**REGULAR MEETING OF THE THIRD LAGUNA HILLS MUTUAL  
ARCHITECTURAL CONTROL AND STANDARDS COMMITTEE**

**Tuesday, May 28, 2019 – 1:30 p.m.  
Laguna Woods Village Community Center Board Room  
24351 El Toro Road**

**DATE:** May 28, 2019  
**FOR:** Architectural Control and Standards Committee  
**SUBJECT:** Variance Request  
Ms. Esther Wen of 3391-B (Malaga, P102A/P42)  
Patio Enclosure on Previously Extended Common Area

**DATE:** May 28, 2019  
**FOR:** Architectural Control and Standards Committee  
**SUBJECT:** Variance Request  
Mr. Richard Siao of 3461-C (Andaluz, P203A/P43)  
Room Extension on Previously Extended Common Area

3391-B Proposed Patio Enclosure & Cover

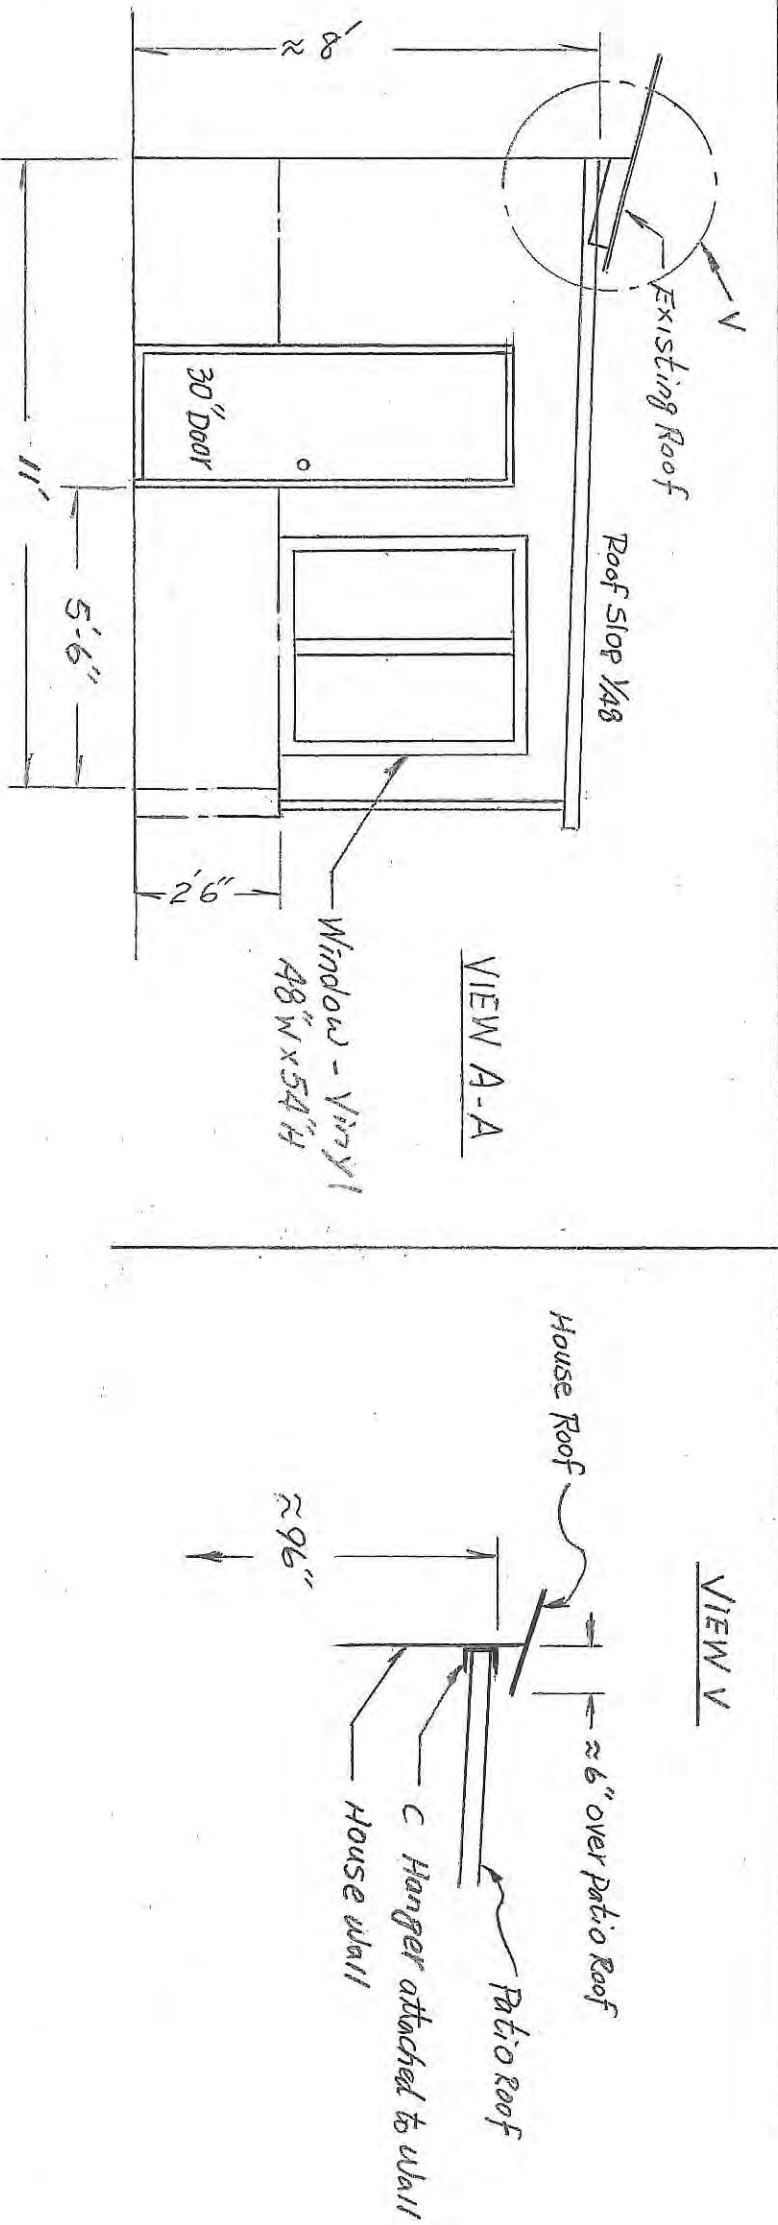
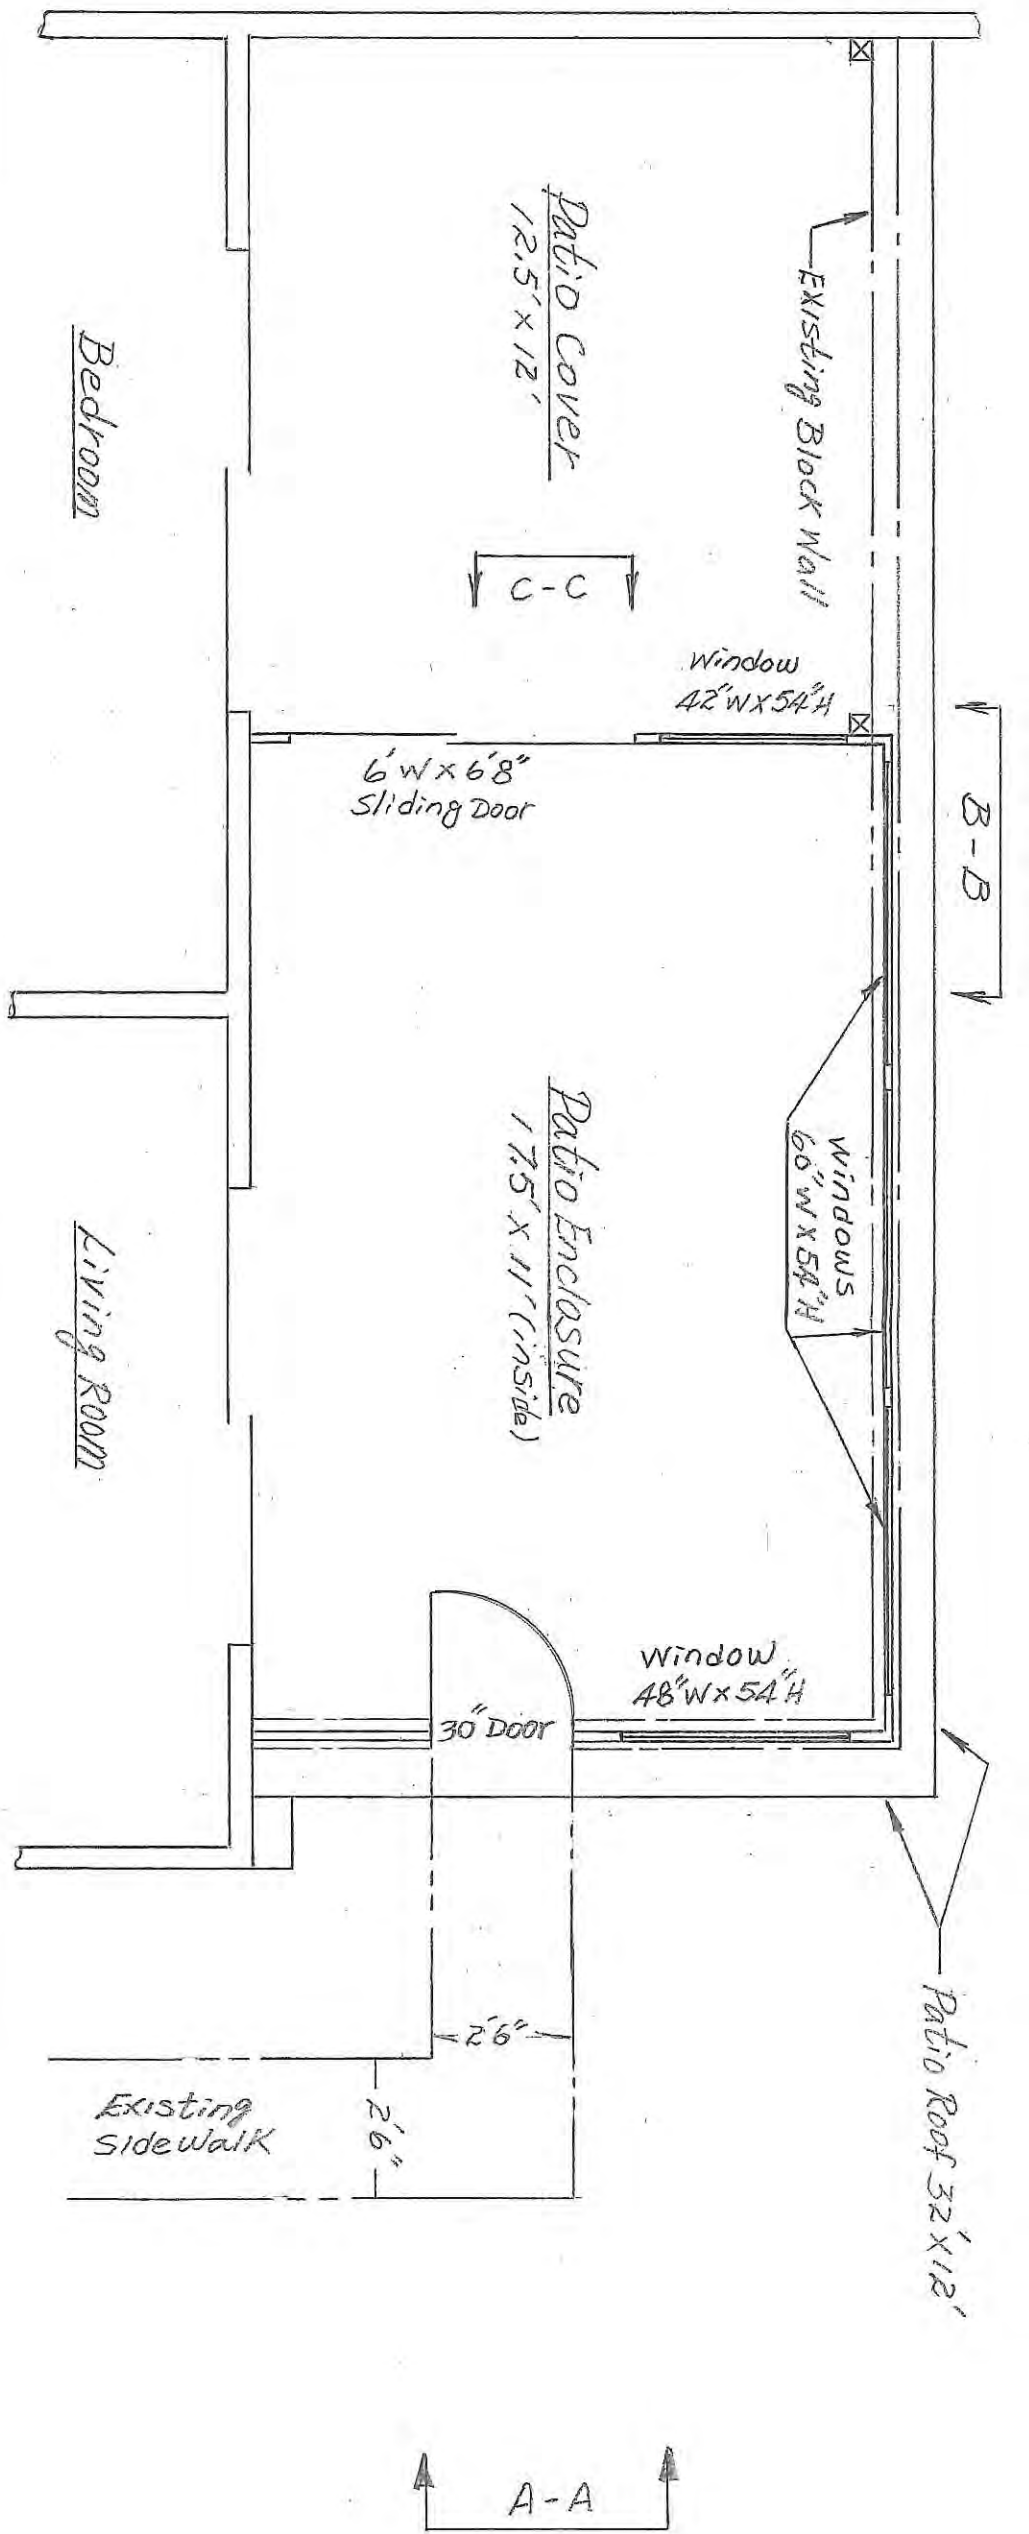
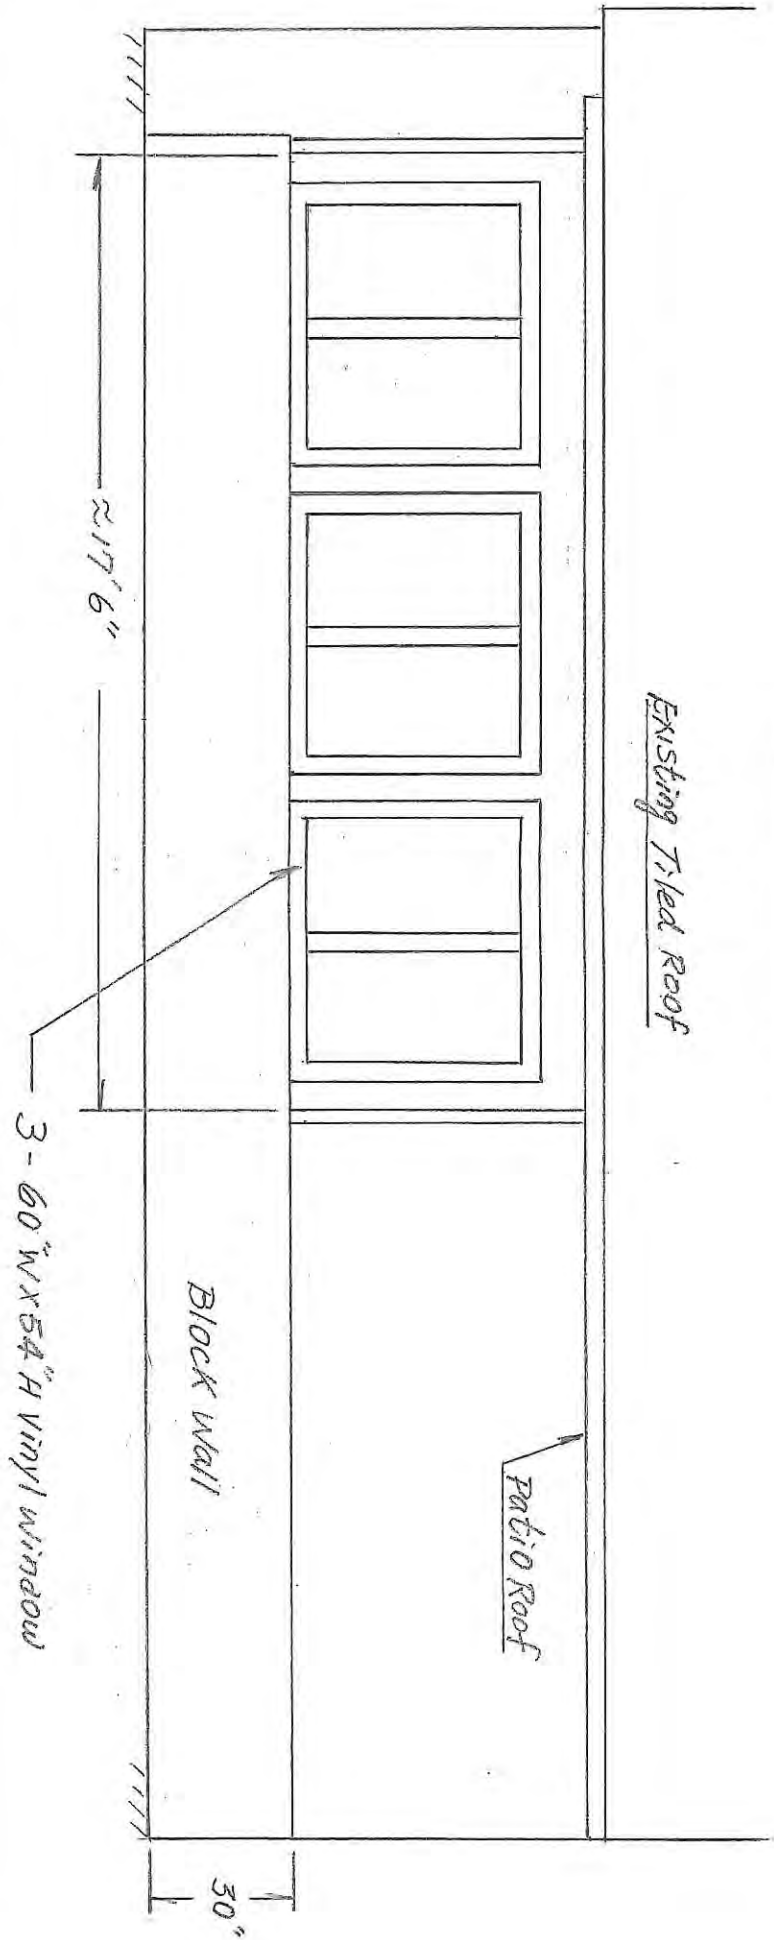
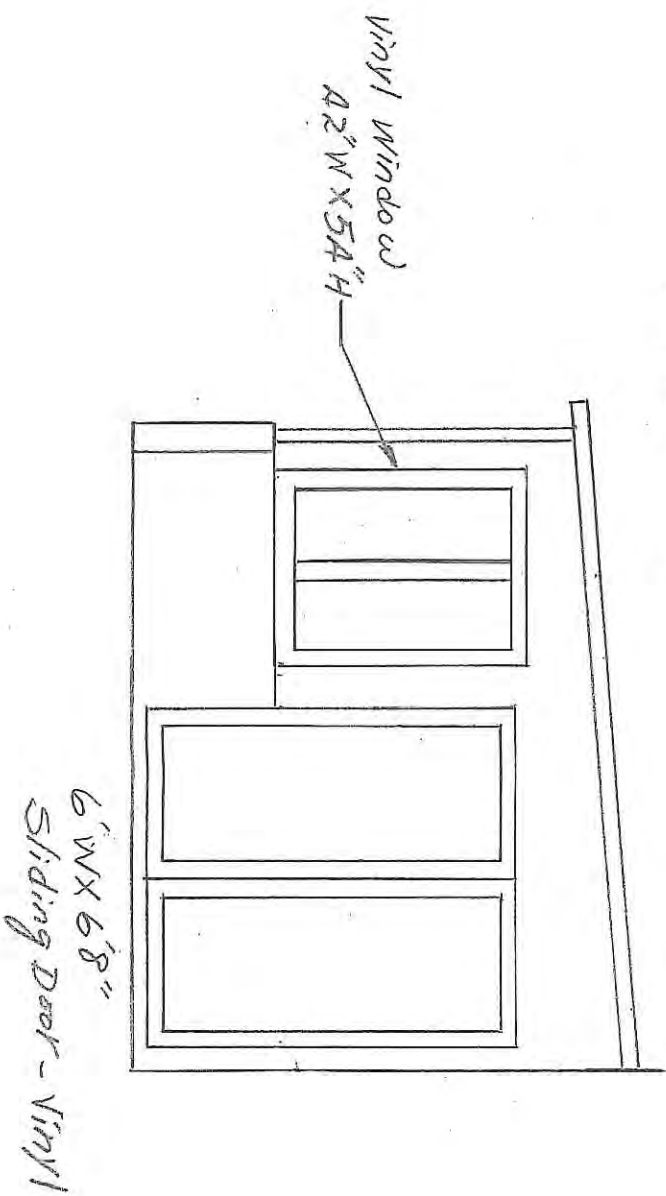
Ms. Wen is proposing to install an aluminum frame patio enclosure measuring 17'6" wide by 11' long, along with a new patio cover to match the enclosures roof measuring 12'6" wide by 12' long.

The existing block wall will be reduced to 30" and aluminum framing installed along with vinyl windows on three sides to enclose part of the patio. The rear elevation would contain three 60" wide by 54" tall windows. The left elevation would contain a 30" wide swing door and a 48"

wide by 54" tall window. The right elevation would contain a 42" wide by 54" tall window along with a 6' wide by 6'8" tall sliding glass door that would open onto the remaining covered patio area.

The new roof/cover would be tied into the building below the existing roof at 8' tall, with a total area coverage of 32' wide by 12' long.

Adequate guttering with downspouts/drainage will be required in conjunction with Mutual Standards.

Staff recommends denial of this request in conjunction with current Third Mutual's Common Area Use Policy (RESOLUTION 03-18-146) "BE IT RESOLVED FURTHER, that no further alteration may be approved or constructed on any previously approved or "grandfathered" alteration that encroaches upon common area, other than like for like, that augments, enlarges, or changes the construction, purpose, or use of the previously approved or grandfathered alteration."

Staff recommends the Board deny the request to construct a patio enclosure on a previously extended Common Area patio. Should the Board approve the request, Staff recommends it be with the conditions in Appendix A.
